UNITED STATES PATENT AND TRADEMARK OFFICE

APPLICATION NO.	FILING DATE	FIRST NAMED INVENTOR	ATTORNEY DOCKET NO.	CONFIRMATION NO.
10/805,074	03/19/2004	George Ord	11836.019403	7913
23469	7590	10/10/2006	EXAMINER	
JAECKLE FLEISCHMANN & MUGEL, LLP 190 Linden Oaks ROCHESTER, NY 14625-2812			BANKHEAD, GENE LOUIS	
			ART UNIT	PAPER NUMBER
			3744

Office Action Summary

DETAILED ACTION

Figure 1 (Mutter US 6341620)

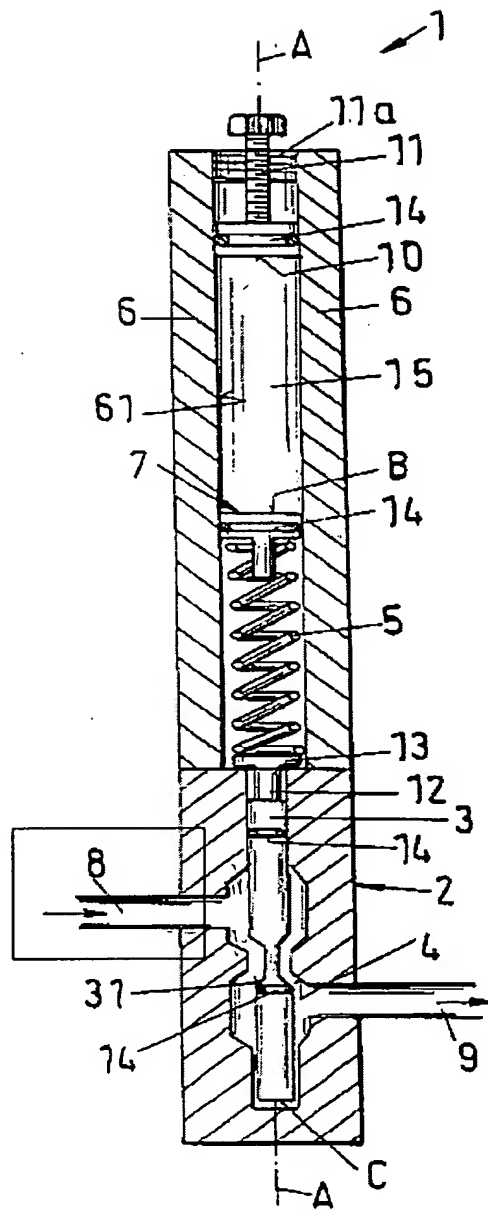
Regarding claim 1, Mutter teaches a temperature compensation valve with an inlet and outlet openings (8, 9). He further teaches an orifice 4 located between the inlet and outlet openings. See Figure 1. He further teaches a means for varying the orifice size to allow for a defined flow rate with fluctuations in temperature (column 1 lines 55-60, column 2 lines 1-20 and column 3 lines 50-60).

In regard to claim 2 Mutter teach a piston 7 positioned across from the inlet to modulate flow rate as a function of temperature. It should be of note the inlet 8 is being considered as the entire portion as outlined in Figure 1.

With regard to claims 3 and 4, Mutter teaches the piston 7 comprises a first side, and a second side. He further teaches the first side is adjacent to a puck 10, and the second side is adjacent to a spring 5. See Figure 1 below.

Regarding claim 5, Mutter teaches a flanged end housing the spring on the second side of the piston.

With regard to claim 7, Mutter teaches the spring urges the piston away from the orifice. Note from Figure 1 the spring exerts a force on the piston in an opposite direction of the orifice.

With regard to claim 9, Mutter teaches the piston 7 further comprises a pair of annular grooves, with an o-ring 14 situated in each groove.

In regard to claims 10 and 11, Mutter teaches a fine tuning adjuster 1, and further teaches the fine tuning adjuster comprises a threaded nut 11 and a threaded fitting 11a. Mutter further teaches as the threaded nut is advanced it urges the puck toward the piston to reduce the size of the orifice. Note Mutter teaches the volume 15 is filled with fluid (column 4 lines 60-67 and column 5 lines 1-5) and that the opening 63, in the inner cylinder 6b, is provided for fluid in the volume to act on the piston (column 7 lines 50-55). Basic principles of fluid mechanics teach it is inherent that as the fine-tuning adjuster advances toward piston 10 the piston 7 will move toward the orifice.

Figure 2 Roach (US 55784)

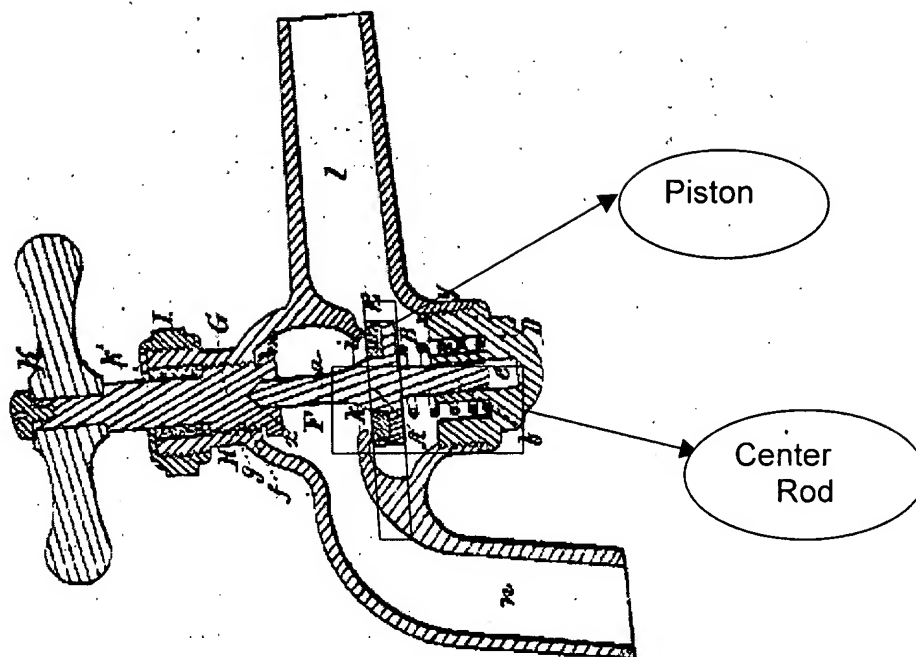
With regards to claims 12-14, Roach teaches a temperature compensation valve with an inlet and outlet opening (l, n); an orifice k between the inlet and outlet openings; and a means for varying the size of the orifice to allow for a defined flow rate with fluctuations in temperature (a). Roach further teaches a piston, see Figure 2 below, positioned across the inlet and capable of modulating flow rate as a function of temperature. Roach further teaches the piston comprises a first side adjacent to a puck w, and a second side adjacent to a biasing means B. Roach further teaches a position measurement rod e, with a center rod (see Figure 2), and an end knob K. Roach teaches the center rod has a first side adjacent to the piston and a second side indirectly attached to the end knob. Roach further teaches the end knob protrudes from the valve to provide a visual indication of the position of the piston. Note, if the distance from the top of the end knob to the bottom of the piston is known the position of the piston inside the valve when the end knob is depressed can be determined from simple mathematics. Roach further teaches the center rod is substantially surrounded by the biasing means B. See Figure 1.

Figure 3 (US 4203545)

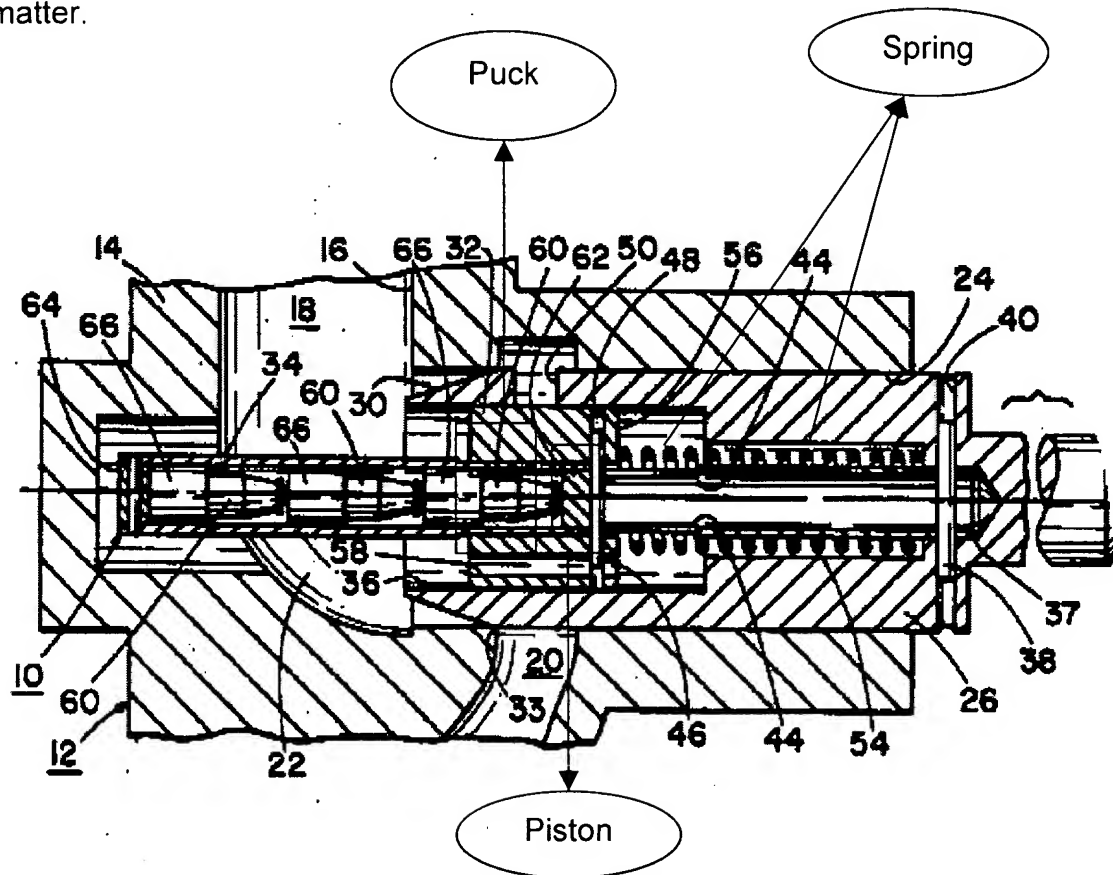
In regard to claims 1,2,3 and 6, Fackler teaches a temperature compensation valve with an inlet 20 and outlet 18. He further teaches an orifice 16 allowing for communication between the inlet and outlet 16, and a piston for varying the size of the orifice based on temperature 32 (column 3 lines 1-20). Fackler further teaches a piston 62 has a first side adjacent to a puck 60 and a second side adjacent to a biasing means 54. See Figure 3 below. Fackler further teaches the puck expands as temperature increases thereby urging said piston toward the orifice (column 3 lines 37-58).
